April 19, 2004

***Re: Comments on the Preliminary Proposal for Federal Columbia River Power System
Summer Juvenile Bypass Spill Operations***

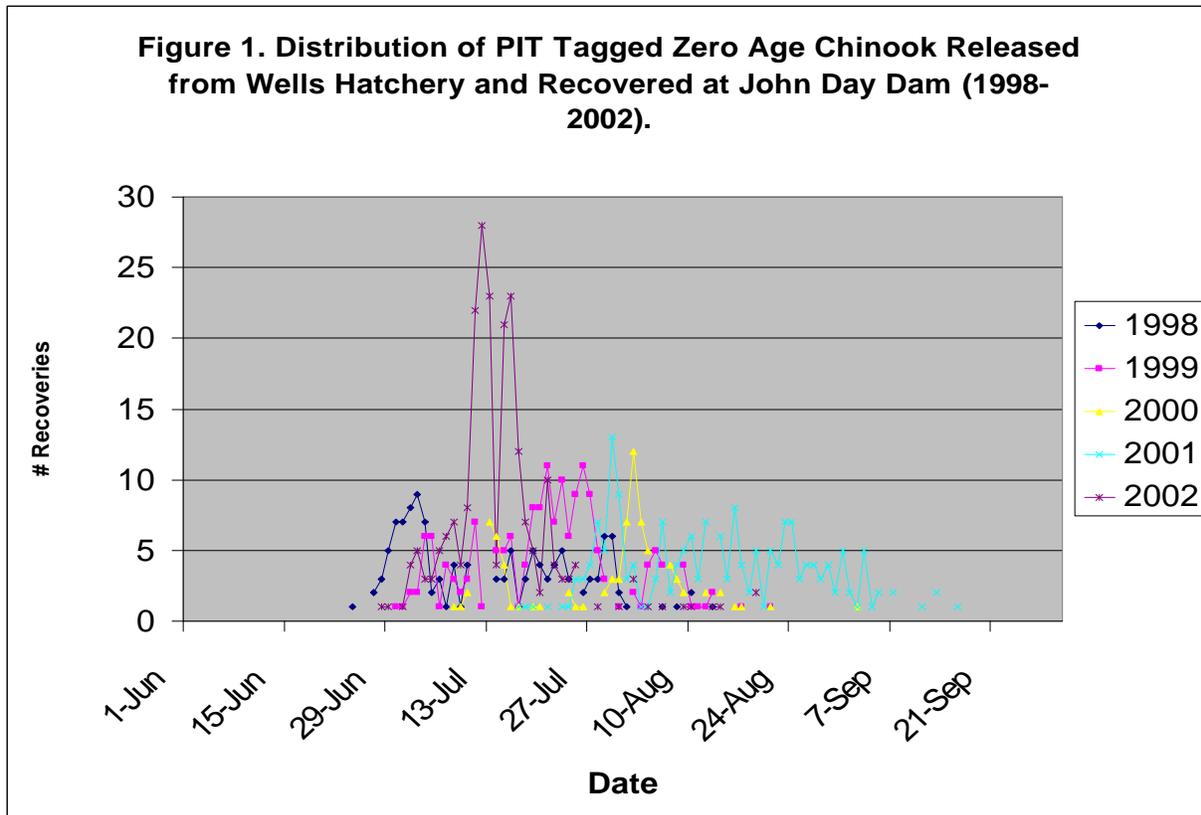
Furthermore, in Table 1 and Figure 1 below, we present five years of PIT tag data that clearly show that upper Columbia summer/fall Chinook are present in the system during the period of proposed spill reduction. The data indicate that **up to 71 percent** of these fish would be subject to impacts associated with elimination of spill.

In addition to the impacts on upper Columbia stocks from elimination from spill, we are further troubled by the Corps' proposal to remove the 1% peak efficiency turbine operating criteria at McNary Dam for the 2004 salmon migrations. Stocks that would be impacted include wild Wenatchee, Okanogan and Methow summer/fall Chinook, sockeye, coho, and endangered upper Columbia steelhead and spring Chinook.

The two vertical lines in figure 2 represent the times when both reduction in spill and removal of the 1% peak efficiency turbine operating criteria would impact upper Columbia stocks.
